PLANNING AND ZONING CASE CHECKLIST

P&Z CASE # SP 2018-023 P&Z DATE 8/14/2018 CC DATE 8/20/2018 APPROVED/DENIED _____
ARCHITECTURAL REVIEW BOARD DATE _____ HPAB DATE _____ PARK BOARD DATE _____

RE: SITE PLAN (SP2018-023), AVID Hotel

Project Number: SP2018-023
Project Name: AVID Hotel
Project Type: SITE PLAN
Applicant Name: PSA ENGINEERING, LLC
Owner Name: ROCKWAY, PARTNERS LLP
Project Description:

SHEET: C-01

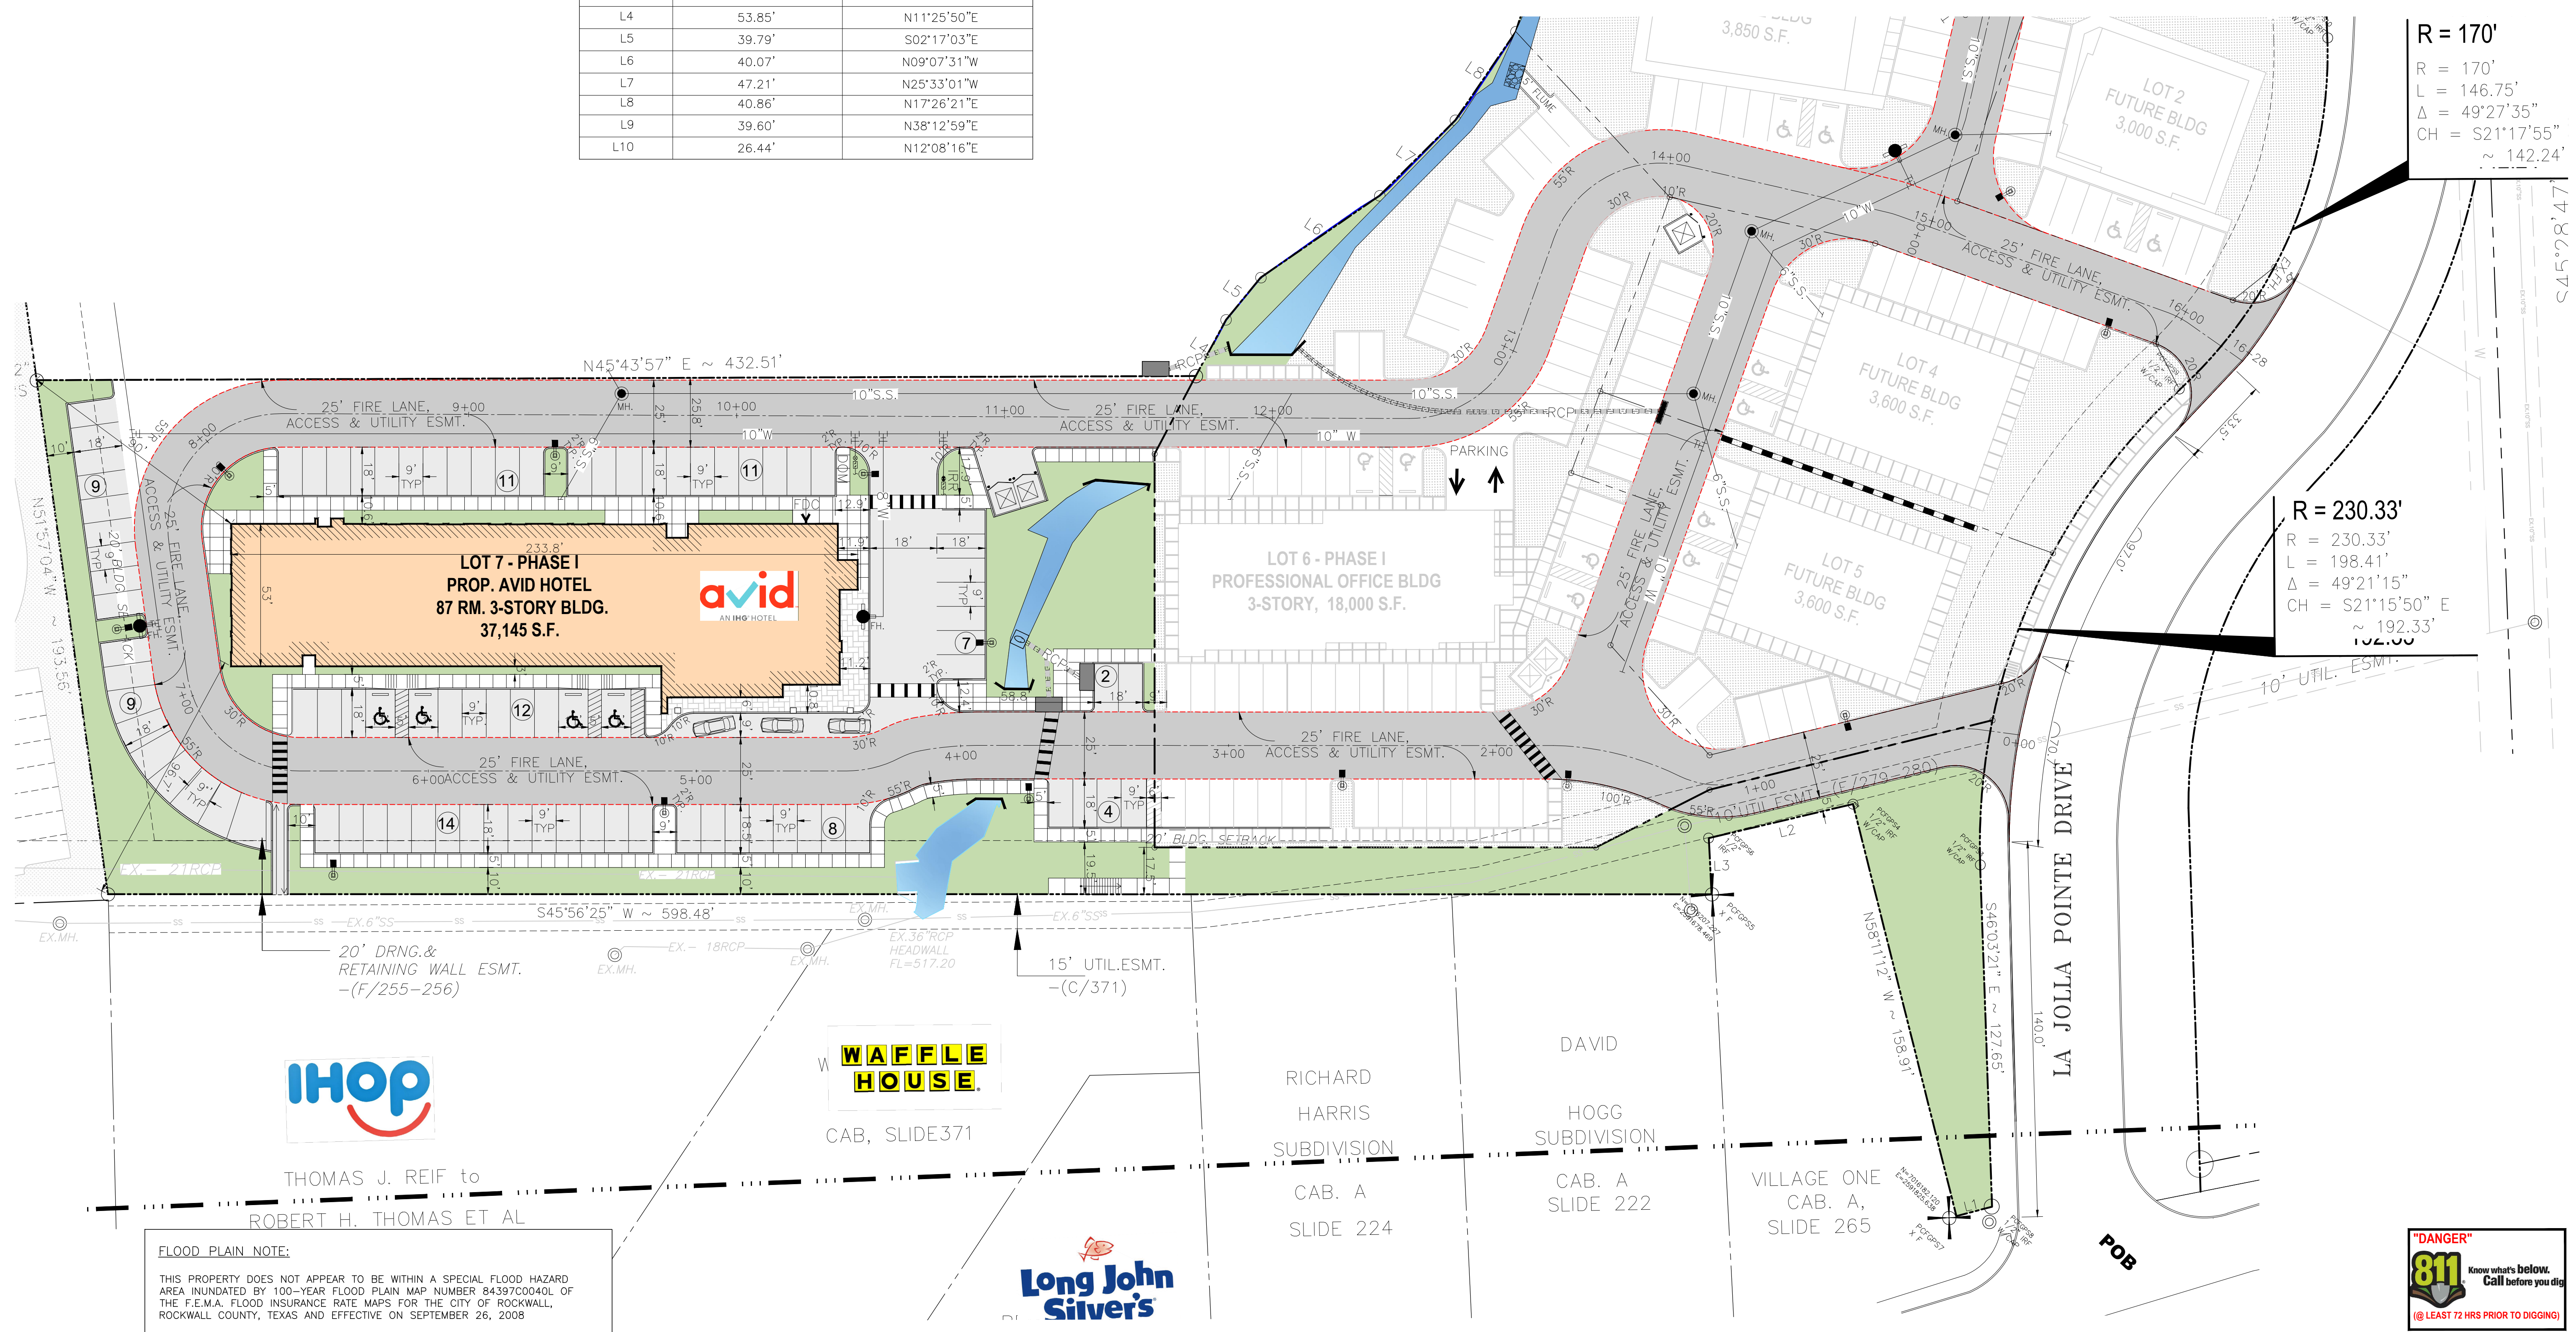
1. Lot as depicted does not meet the minimum standards for a legal lot; minimum 60-ft frontage along a public street and a minimum of 100-ft lot depth. Submit preliminary plat concurrently with site plan.
2. Relabel all firelane as '25-ft Firelane, Public Access & Utility Easement as appropriate (i.e. if no utility within easement, do not include Utility).
3. Dumpster enclosure to be reoriented; not facing the street.

Type of Review / Notes	Contact	Sent	Due	Received	Elapsed Status	Remarks
4. Dumpster enclosure to include a self latching gate mechanism and gate to be opaque 5. Dumpster enclosure walls to a minimum of 8-ft in height with the exterior materials matching the primary structure 6. Provide a minimum 10-ft landscape buffer along La Jolla Pointe Drive and label as such 7. Variance to horizontal articulation required as noted above with recommendation from ARB and R&Z.						
Landscape Plan:

SCALE: AS SHOWN
 DESIGNED: PSS
 DRAWN: PSA
 CHECKED: PSS
 PROJECT NO. 21737.VPR
 DATE: SEPTEMBER 14, 2018
 SHEET: C-01

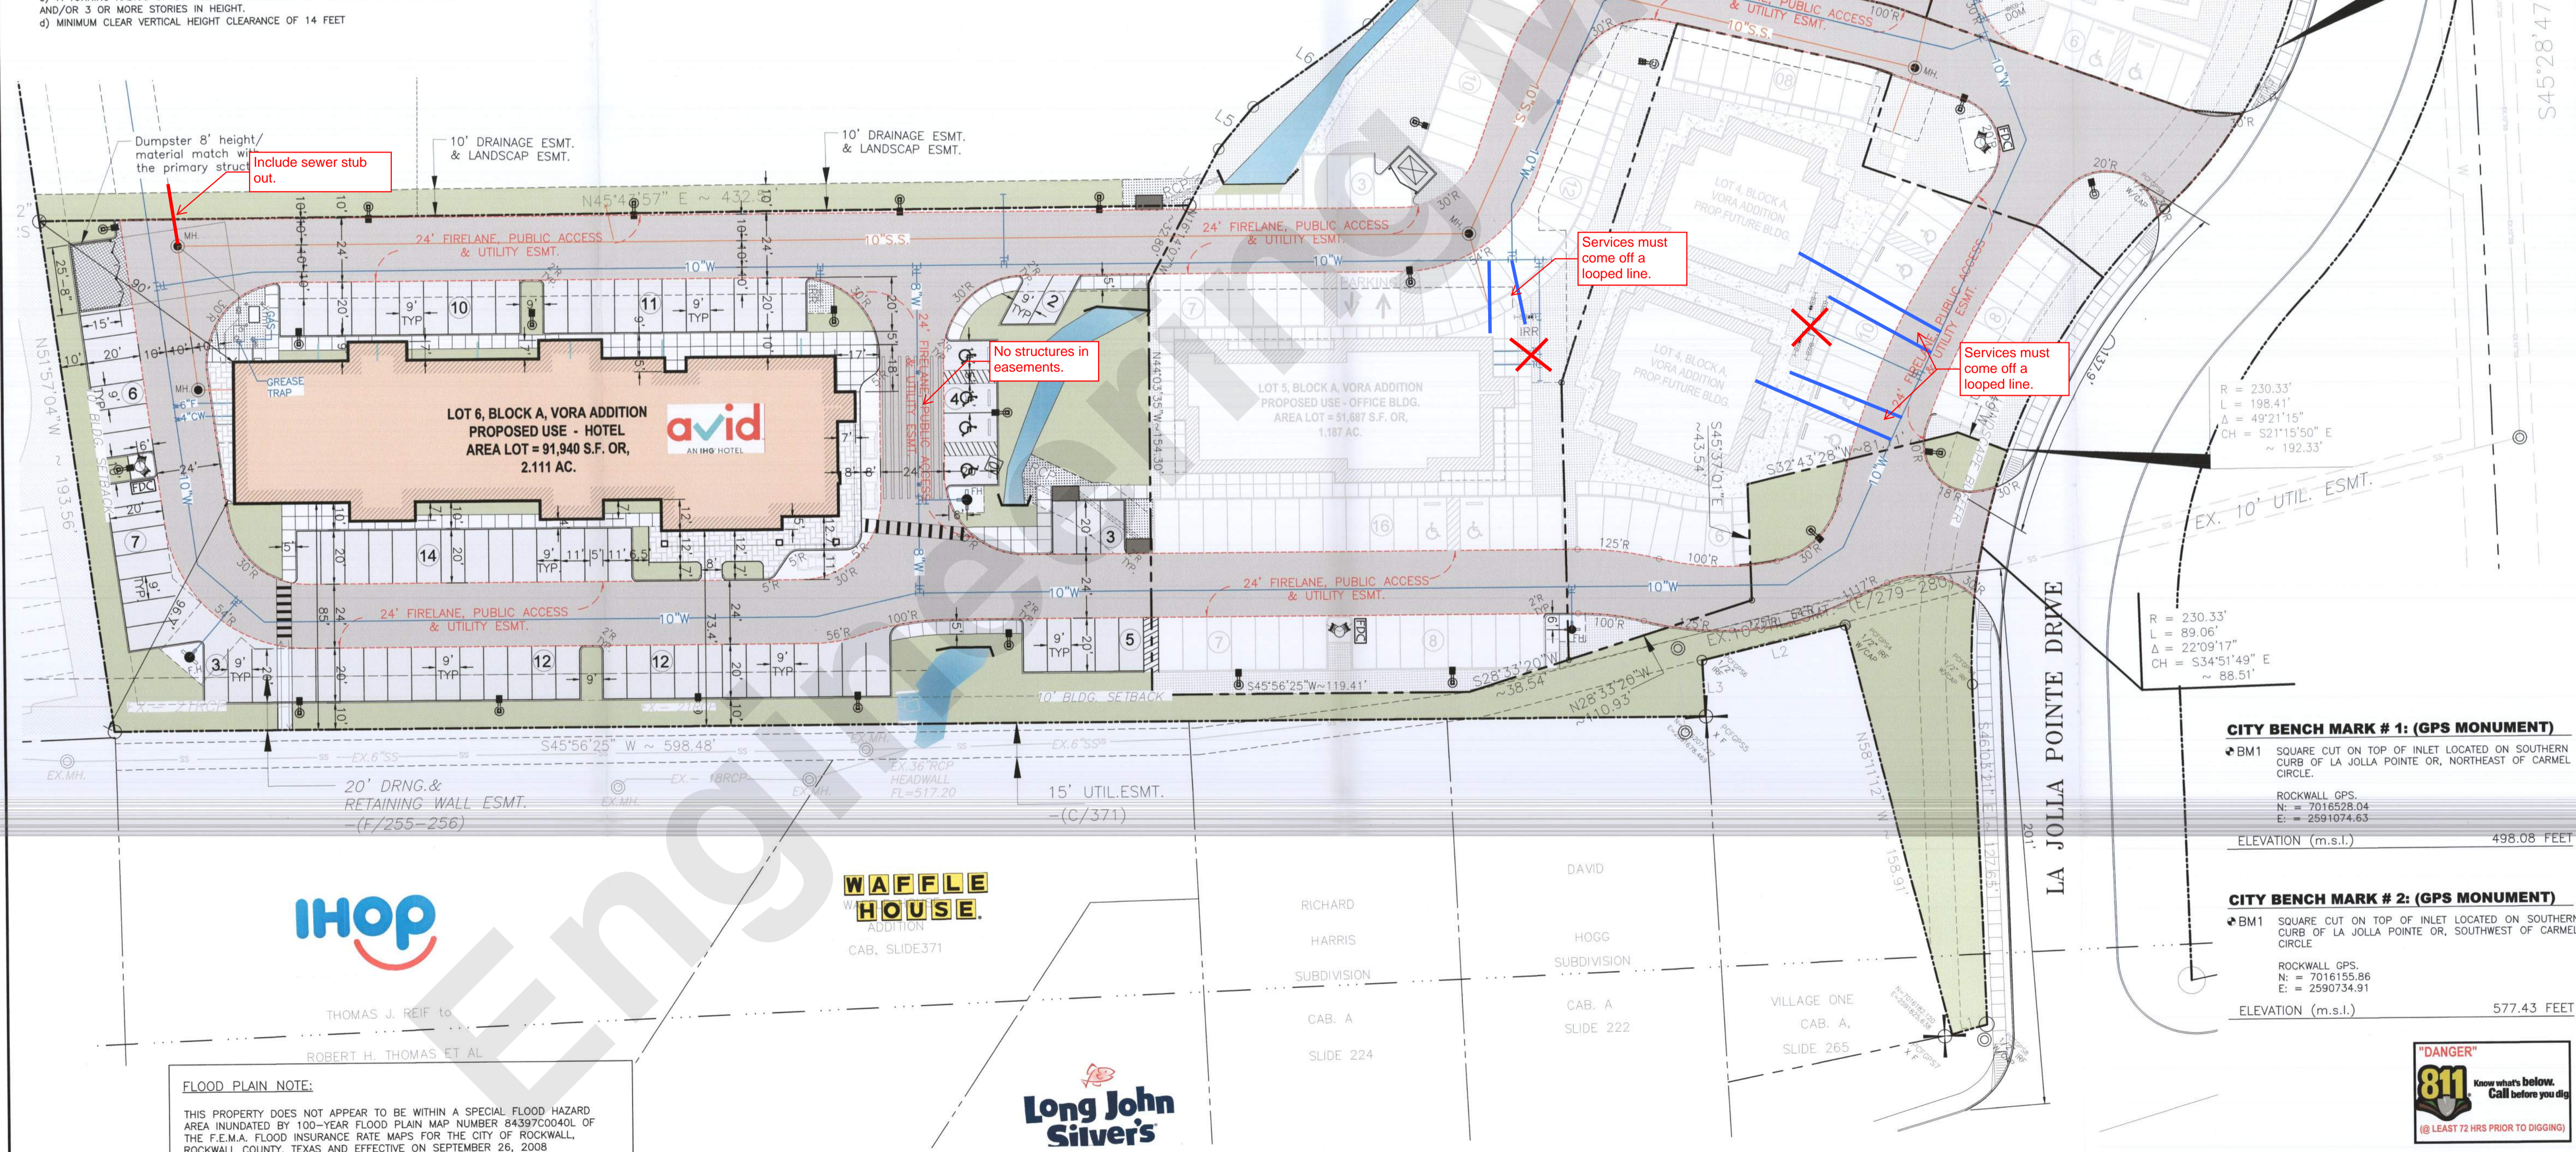
Must show offsite utilities on Site Plan.
 No other engineering sheets were reviewed with this submittal.
 Water and sewer are on Site Plan. Drainage not reviewed until engineering review.
